World Forum for Harmonization of Vehicle Regulations

Proposal for Supplement 2 to the 06 series of amendments to UN Regulation No. 22 (Protective helmets)

Submitted by the Working Party on Passive Safety *

"Annex 2A

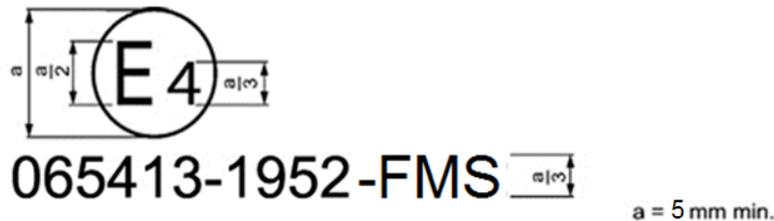
Annex 2A, amend to read:

The above approval mark affixed to a protective helmet shows that the helmet type concerned has been approved in the Netherlands (E 4) under approval number 061406.

The approval number shows that this approval concerns a helmet which has a lower face protective cover (P) and was granted in accordance with the requirements of UN Regulation No. 22 already incorporating the 06 series of amendments at the time of approval, that it can be fitted with a universal accessory having speakers and mounted in the front or in the side of the helmet and that its production serial number is 1952,

Example of the arrangement of the approval mark for a specific accessory

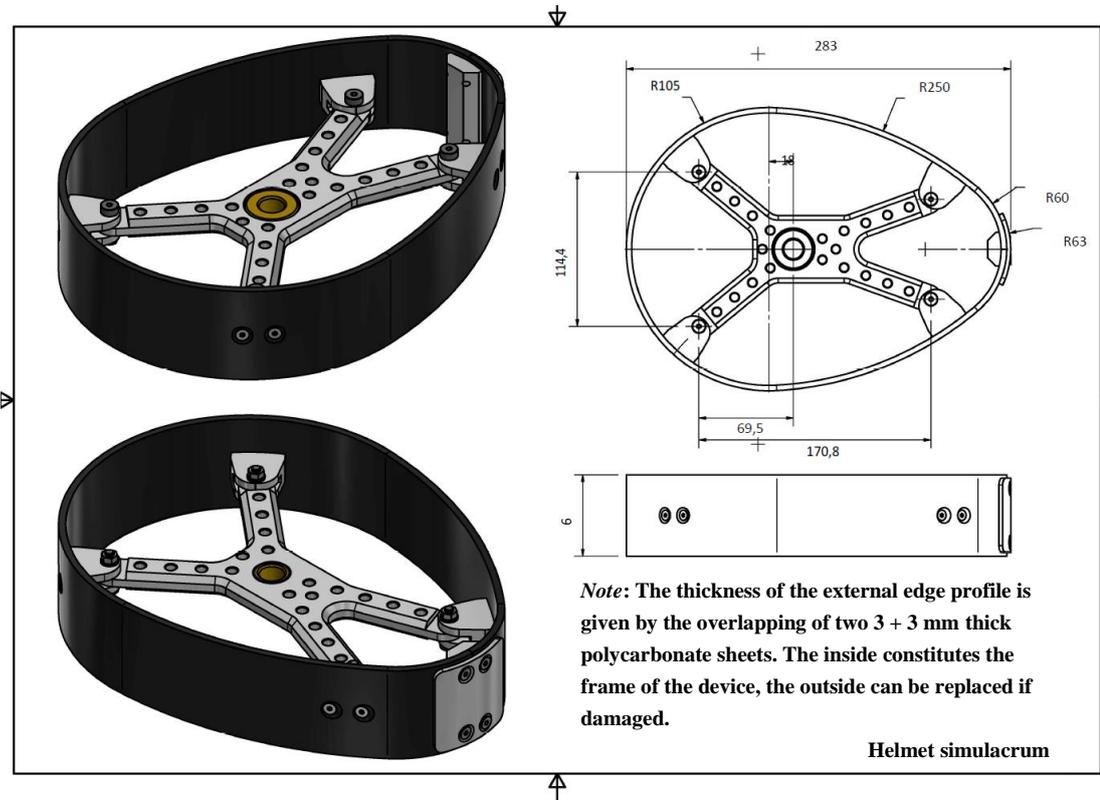
Insert a new Annex 2C, to read:

The above approval mark affixed to a specific accessory shows that the specific accessory type concerned has been approved in the Netherlands (E 4) under approval number 065413. The approval number shows that approval was granted in accordance with the requirements of the Regulation incorporating the 06 series of amendments at the time of approval, and that its production batch is 1952."

Figure 1

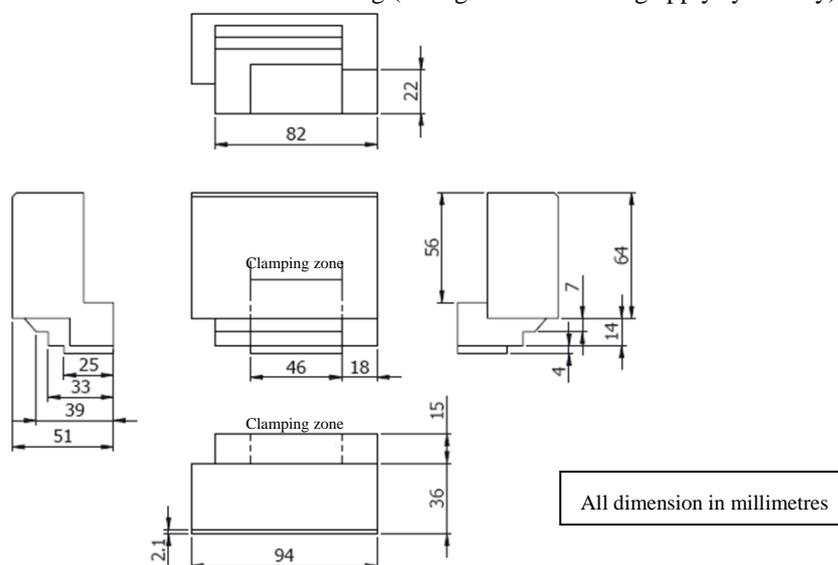
1.1.1. For front mounted accessories:

Fixture for left front- side mounting (for right side mounting apply symmetry)

Figure 3

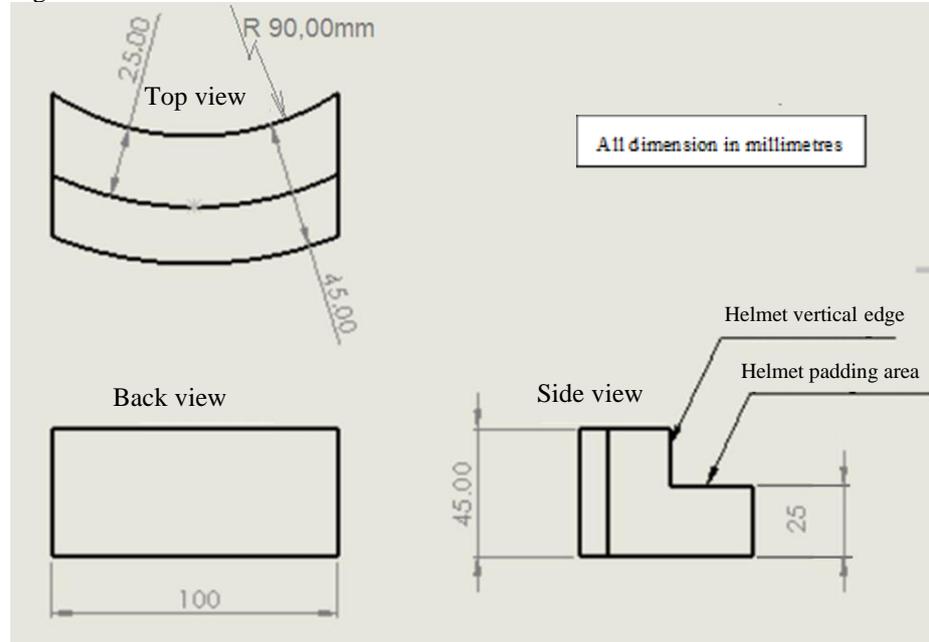
- 1.1.3. For rear mounting accessories

The rear mounting clamping solution offered by the accessory manufacturer will not invade the impact-affected area unless it fulfils the provisions laid down in this Regulation for those parts entering into the impact affected areas.

Figure 4
Speakers quasi static crush test corridor

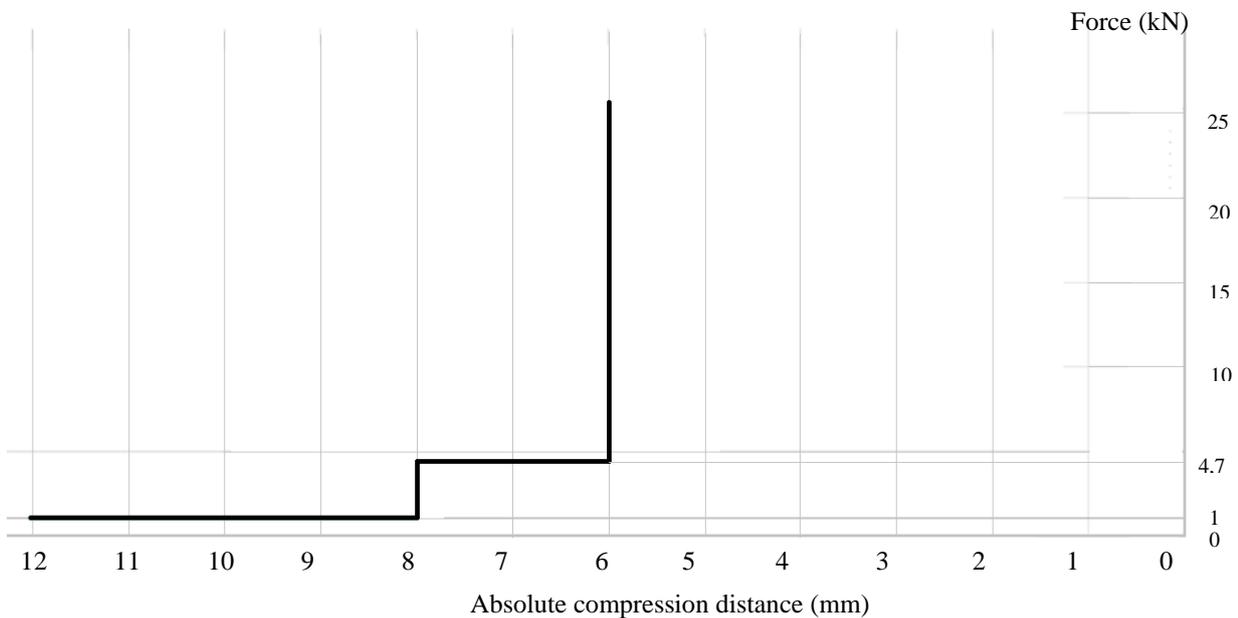
- Measure the distance between the two supports.
- Set the zero displacement setting.
- Start the crush test at a constant speed of 10 mm/min. Record force vs distance at a minimum sampling rate of 10 Hz.

- The test ends when the force reaches 10 kN.
- The obtained chart for the speakers shall fall below the line defining the upper corridor limit.

Figure 5
Speaker simulator

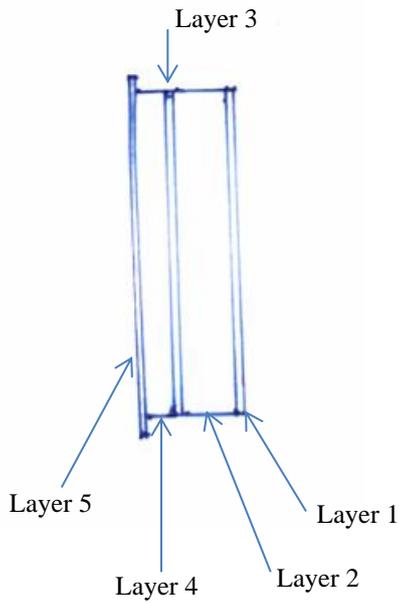
The speaker simulator is illustrated in Figure 5 of this annex. The dimensions of the individual components of the speaker simulator are listed separately below. The below layers are a possible construction methodology, alternative possibilities are valid provided that they will fulfil the requirements of 1.4.1.3.

- Diameter: 40 mm/45 mm
- Tolerance: +0-1 mm
- Thickness: 1 mm \pm 0.07 mm
- Material: Aluminium 5251/5052 (ISO 209, part 1)
- 1.4.1.1.6. Adhesive
- The adhesive to be used throughout should be a two-part polyurethane (such as Ciba-Geigy XB5090/1 resin with XB5304 hardener, or equivalent).

Figure 6
Speaker simulator force-deformation corridor

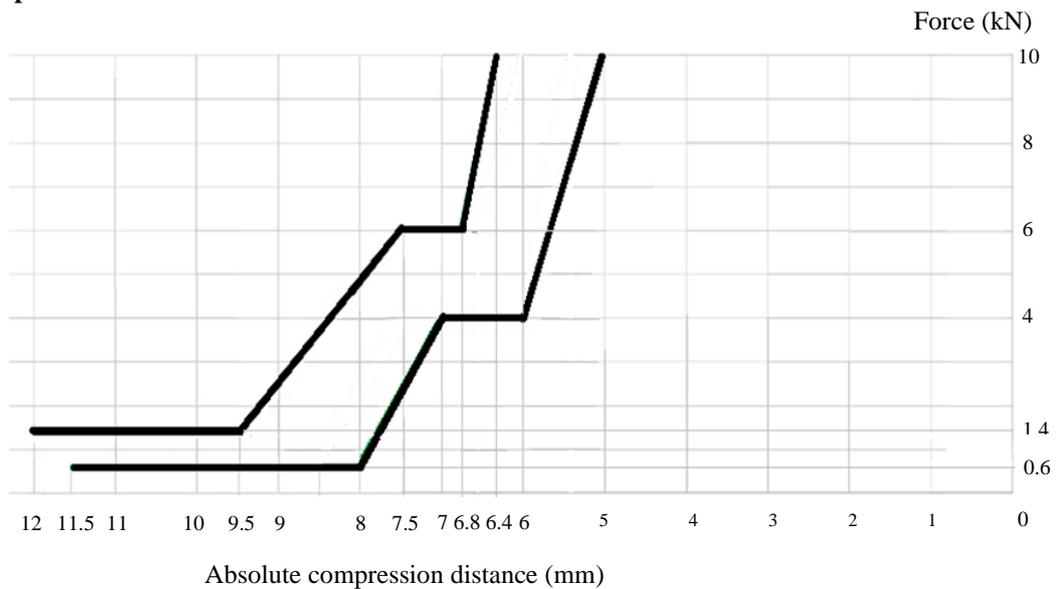
- 1.4.1.2. Aluminium honeycomb certification and simulator characterization
 - 1.4.1.2.1. A certificate of the aluminium honeycomb performances will be necessary to ensure that the prescriptions of the above paragraph 1.4.1.1. will be fulfilled.
 - 1.4.1.3. Simulator performance check
 - 1.4.1.3.1. To ensure the proper behaviour of the speaker simulator, the TS shall ensure that the force-deformation curve will lay within the limits stated in Figure 6.

- 1.4.1.3.2. If the force-deformation curve of the simulator pass over the upper corridor limit or below the lower corridor limit by no more than 0,5 mm, the simulator is considered to pass.

Figure 7

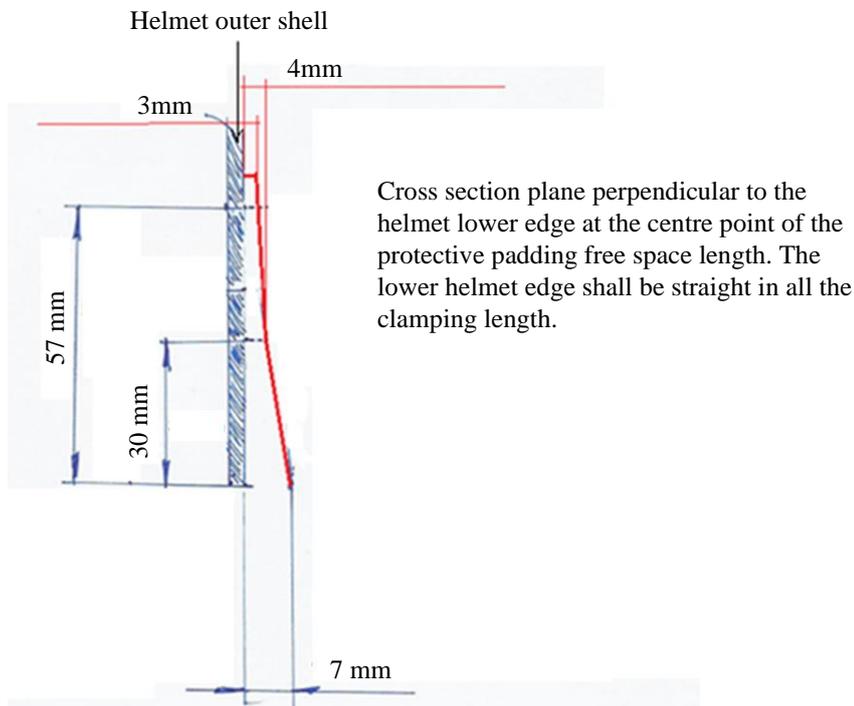
- 2.1. The helmet clamping free space dimensions for front and side mounting will be, at least, the following ones:

Free protective padding space for accessories clamping for front and side locations of UA helmets

The length of clamping zone will be according to the fixture drawings.
